CASE SUMMARY SHEET**CASE NUMBER: V23-04-13****DATE RECEIVED: March 10, 2023****DATE OF MEETING: April 11, 2023 and April 25, 2023****Address: 1617 Lakeshore****Subdivision: Old Town of Mandeville, Square 5 Lot 6****Zoning District: R-1 Single Family Residential****Property Owner: Allison and Brian Froeba****REQUEST: V23-04-13 – Allison and Brian Froeba request a variance to CLURO Section 5.2.3.2. Drainage Overlay District and Fill Sub-Area A, Square 5 Lot 6, R-1 Single Family Residential District, 1617 Lakeshore Drive****PREVIOUS CASES: V23-04-12 – Live Oak Dripline Encroachment****CASE SUMMARY:**

From: Clifton Siverd
Sent: Tuesday, May 16, 2023 3:08 PM
To: Alex Weiner
Cc: Cara Bartholomew
Subject: RE: P&Z May Fill Variance Cases

CASE SUMMARY SHEET**CASE NUMBER: V23-05-18****DATE RECEIVED: April 18, 2023****DATE OF MEETING: May 9, 2023 and May 23, 2023****Address: 816 Carondelet Street****Subdivision: Pine Place, Square A Lot 29****Zoning District: B-2 Highway Business District****Property Owner: Roger Williamson**

DRAINAGE PLAN

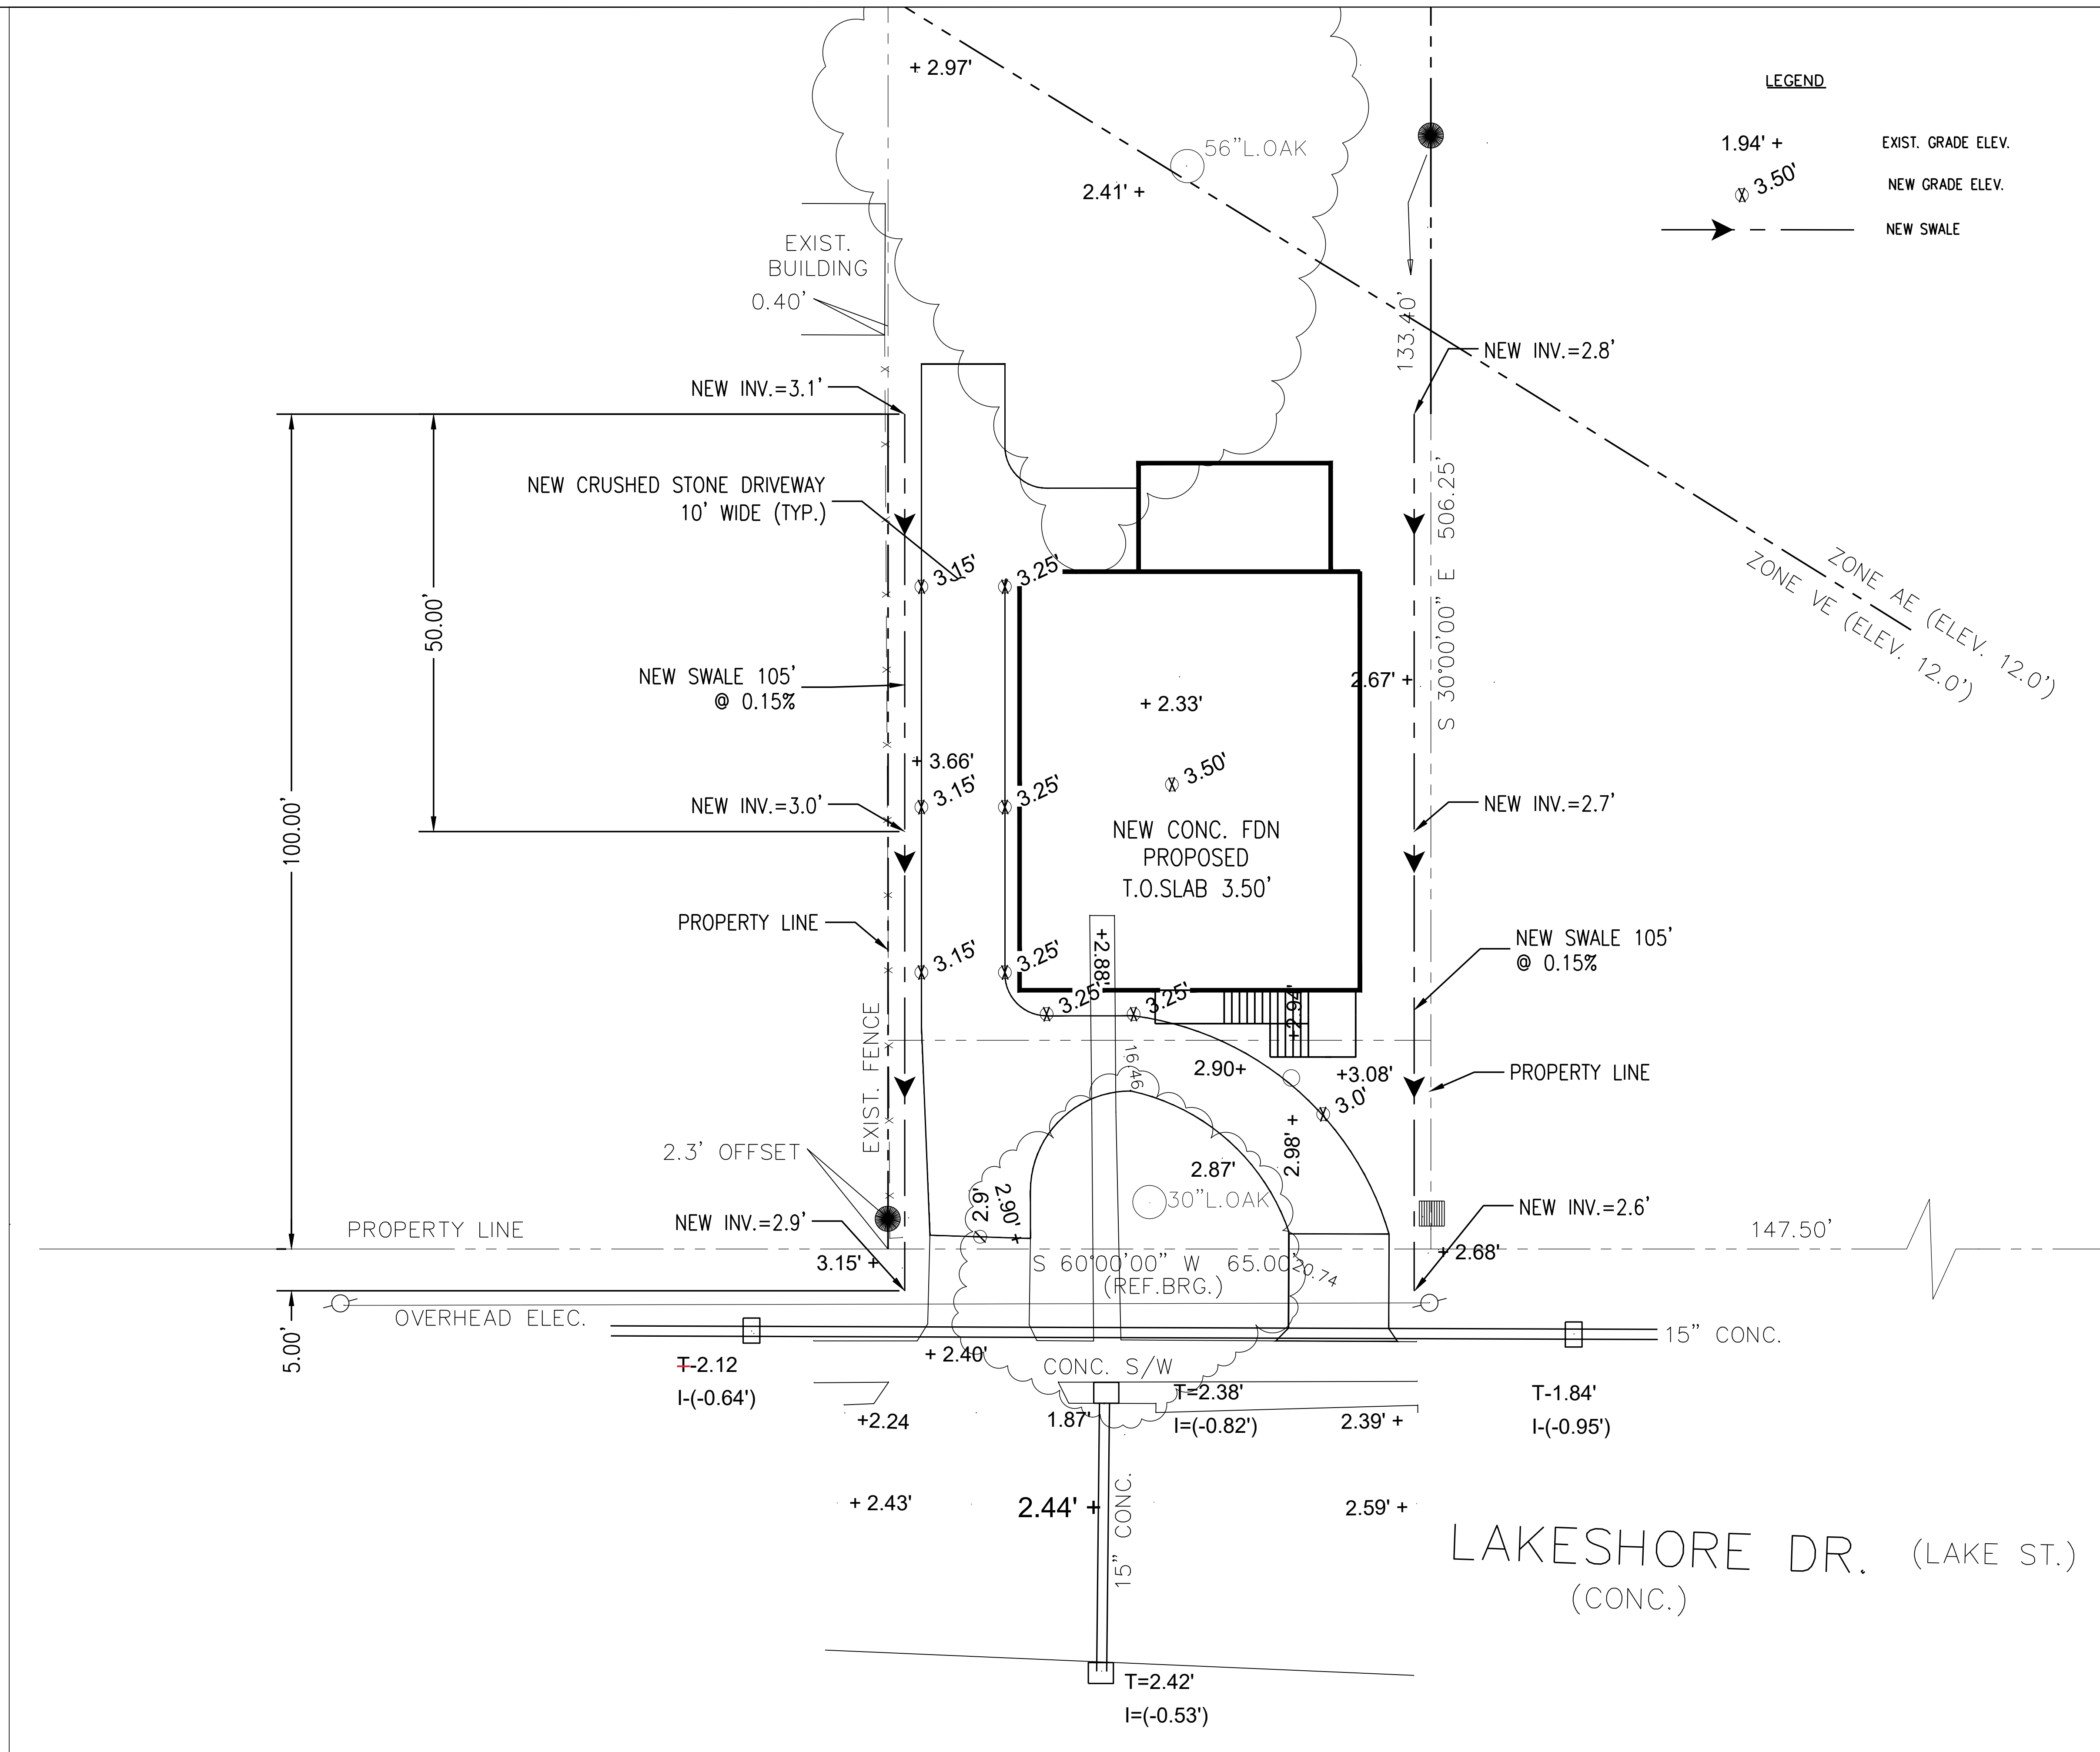
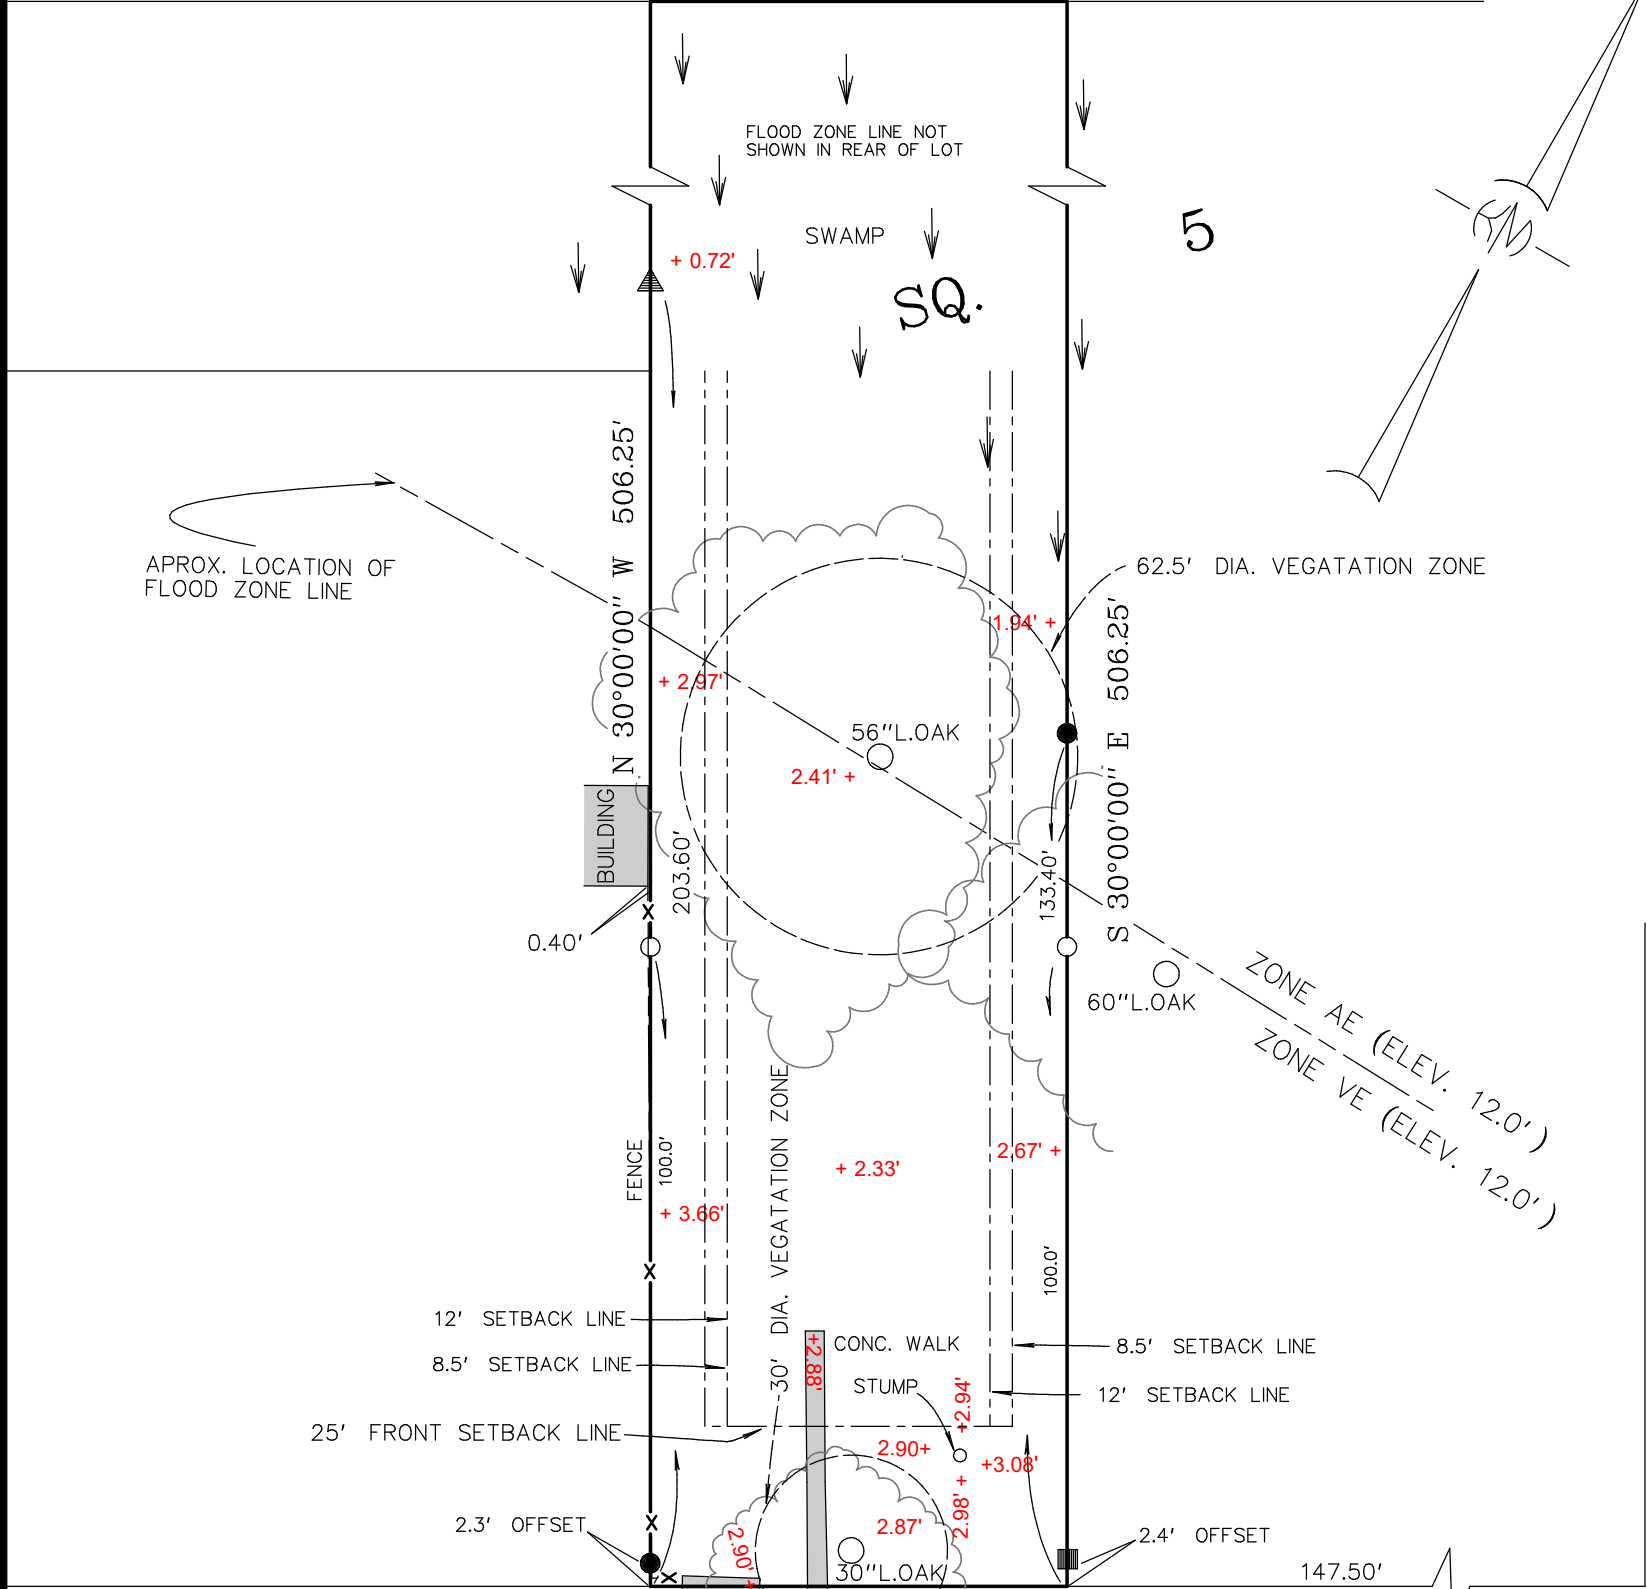
Alex,
Public works has no exceptions on elevating the bottom slab height for 1617 Lakeshore Drive. Future development must follow the drainage plan.

Concrete Retaining Wall

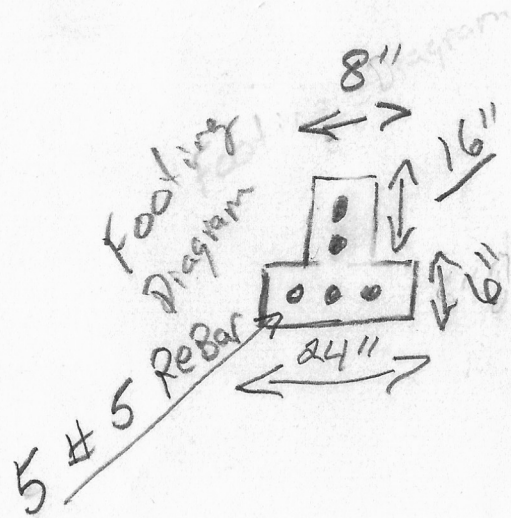
The only exception would be the applicant can not fill the yard to the top of the chain wall if it is approved. The existing drainage pattern must remain.
